Title: Inspection and Replacement of the roll and pitch bolt		
AG-SB-2024-03-B-EN	Effective Date: 20.03.2024	Compliance Category: A – MANDATORY B – RECOMMENDED C – OPTIONAL
Applicability		
Aircraft type & model: All models	Affected Serial number(s): All models built between 05.2023 and 02.2024, Affected serial numbers in the description	
The maintenance manual to be referenced is this stated or subsequent issue.		As per AutoGyro website
This form is the response from AutoGyro GmbH either against a problem found in the product in service requiring a containment or rectification action, or as service information for aircraft modification incorporation. For help, contact airworthiness@auto-gyro.com .

This service bulletin provides instructions on how to inspect and replace the roll/pitch bolt with part number 20675.

Marking of the incorrect bolt:

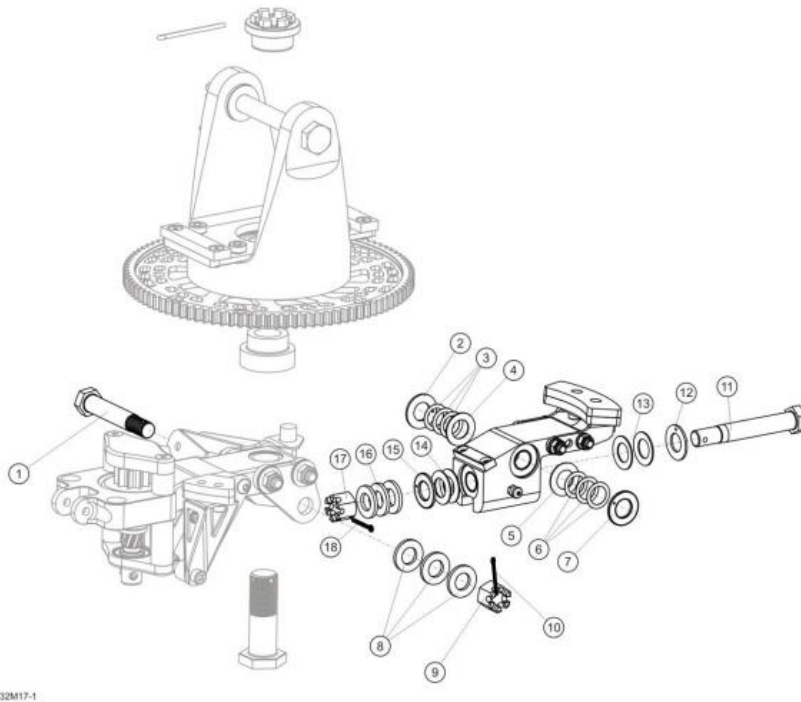
If the screw head looks like this the bolt needs to be replaced.

MTOsport 2010; If affected, then both pitch and roll bolts are to be changed.

MTOsport 2017, Cavalon and Calidus; If affected, then only the roll bolts are to be changed.

Fig. 2 - Rotor gimbal head

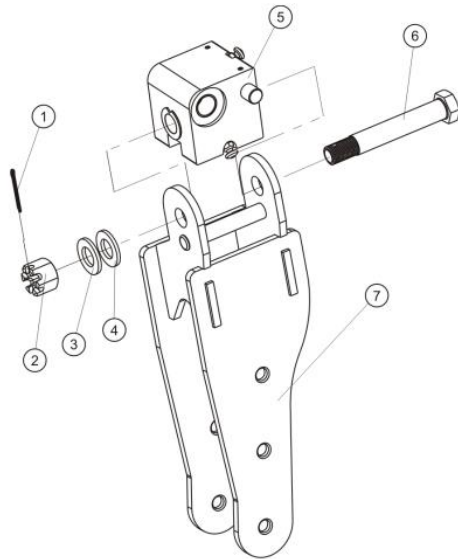
- 1.) Remove the rotor system in accordance to chapter 62-11-00 4-1 Removal: Rotor – Teetering parts
- 2.) Remove bolt (nr.6 and nr.15) and check if the right one is installed
- 3.) Replace the incorrect bolt and tighten it according to chapter 62-32-00 5-1: Check – Adjustment: Rotor Control Friction
- 4.) Re-install rotor system according to 62-11-00 4-4 Installation: Rotor – Teetering parts
- 5.) Perform a FOD inspection and a test flight

Fig. 1 - Gimbal head assembly

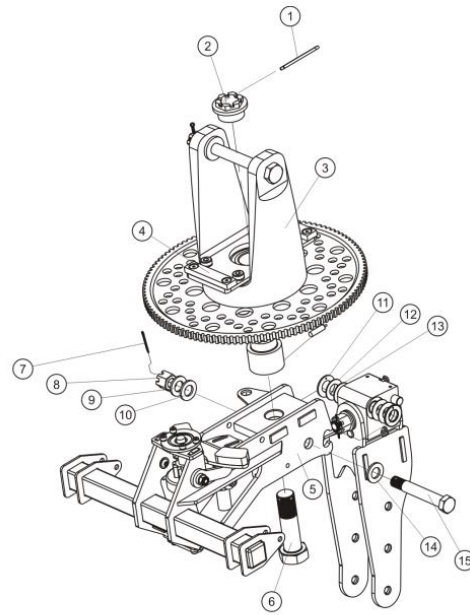
- 1.) Remove the rotor system to relieve the load from the gimbal head according to job card 62-11-00 4-1 Removal: Rotor – Teetering parts
- 2.) Remove the split pin and the washers and carefully remove the roll bolt (nr.11)
- 3.) Replace the incorrect bolt with PN 20675 and re-install the bolt according to chapter 62-32-00 5-1: Check – Adjustment: Rotor Control Friction
- 4.) Re-install the rotor system according to job card 62-11-00 4-4 Installation: Rotor – Teetering parts
- 5.) Perform a FOD inspection and a test flight.
